Proceedings of the Madras Government, Public Works Department, 13th October 1866.

Passing orders on certain correspondence containing the proposals of the Superintending Engineer of the 7th Division and of the Inspector General of Jails, relative to the projected Jail at Cannanore in the Malabar District } (Here enter 5th October 1866, No. 1,562.)

I have the honor to submit, herewith, the plans for the new Central Jail at Cannanore, called for in G. O., No. 3760, of 13th December 1865.

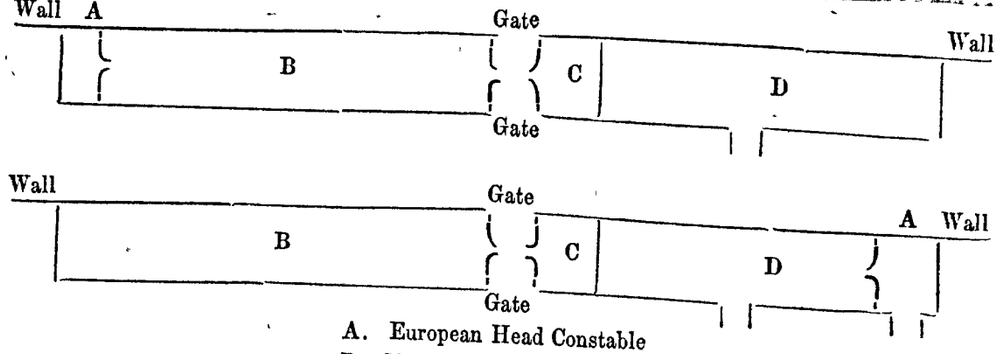
2 With regard to the distribution of the Guard between the Guard-rooms and Central Tower, I would propose to have only 12 or 14 in the latter—the area being somewhat limited, and the remainder in the Guard-rooms I annex a rough sketch of these, showing two arrangements, and request you will let me know which you prefer. The number of Policemen in each will be regulated, so that both buildings may be of the same size.

A. European Head Constable
B. Main body of Police.
C. * 10 Warders.
D. The balance of Police so calculated as to equalize the size of the two Guard-rooms.

* 5 will be enough
